INDESIT company

Model type:
IDL70EU

Commercial code:
F030654

Notices

N1045072FIG1

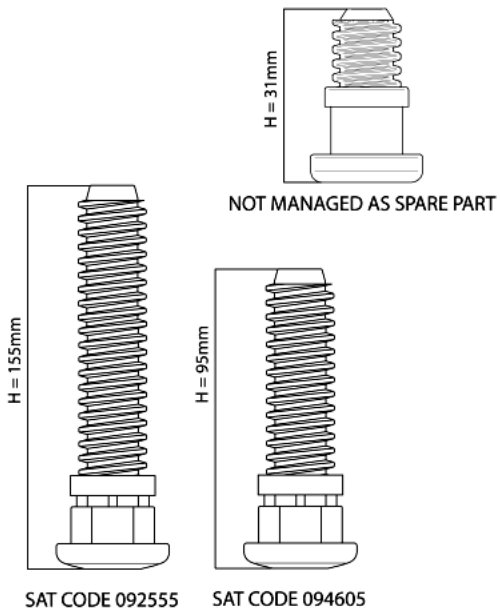
N1045072: Introduction of fixed rear foot H=31mm on free-standing models.

From serial no. 40218.0001, free-standing dishwashers affected by this modification have been equipped with new fixed rear feet (H=31mm).
The new foot replaces the adjustable one (H=155mm) Service code 092555; on the EVO3 range with TurboDry the new foot replaces the adjustable foot (H=95mm) Service code 094605.
The Spare Part Warehouse will continue to manage only 155mm and 95mm adjustable feet as they are interchangeable with the fixed 31mm foot.
The three feet are shown in illustration N1045072FIG1.

N1045083FIG1

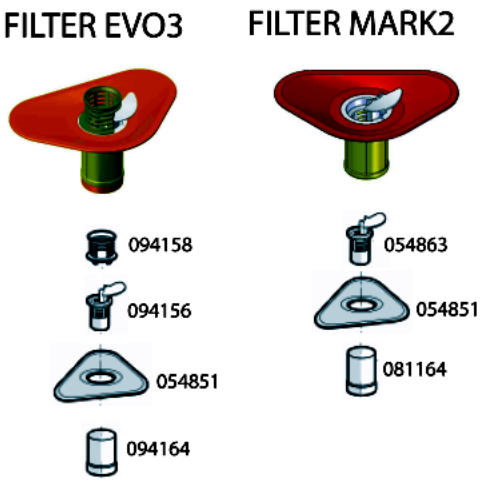
n1045083: Modification of filters on EVO3 60 cm dishwashers

All dishwasher models affected by this modification have been equipped with the items listed below, in order to solve the drain pump clooging problem.

Introduction of:
Cylindrical plastic filter code 081164
Central filter code 054863

Elimination of:
Cylindrical plastic filter code 094164
Central filter code 094156
Central filter grid code 094158

The modification has been introduced progressively, starting from serial no. 40516.0001.

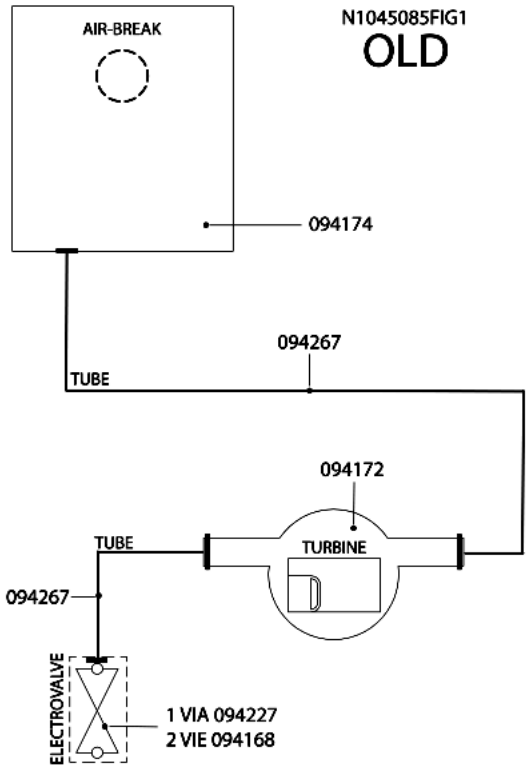
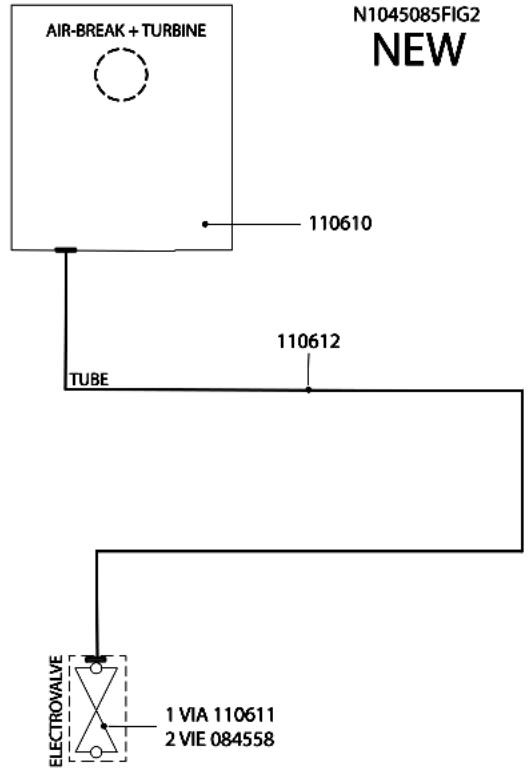
n1045085: Introduction of new litre counter turbine integrated on air-break.

All dishwashers affected by this note have been equipped with a new litre counter turbine on the air-break.
Picture N1045085FIG1 illustrates the premodification structure, picture N1045085FIG2 the new structure.

Items affected by the modification.

AIR-BREAK:
new 110610;
premodification 094174;
the new item features a new integrated litre counter turbine and its water supply hose has a smaller diameter.

LITRE COUNTER TURBINE code 094172 has been eliminated.

SOLENOID VALVES:
new:
1-WAY code 110611;
2-WAY code 084558(Rohs 143737);
premodification:
1-WAY code 094227;
2-WAY code 094168;
the new solenoid valves have a smaller diameter drain hose fitting.

HOSES:
new solenoid valve hose/air-break code 110612;
premodification turbine hose/air-break code 094267;
premodification solenoid valve hose/air-break code 094267;
the new hose has a smaller internal diameter.

WIRING:
the litre counter turbine connecting cable is longer, but since the connector is the same, the new item can be used in place of the premodification one.
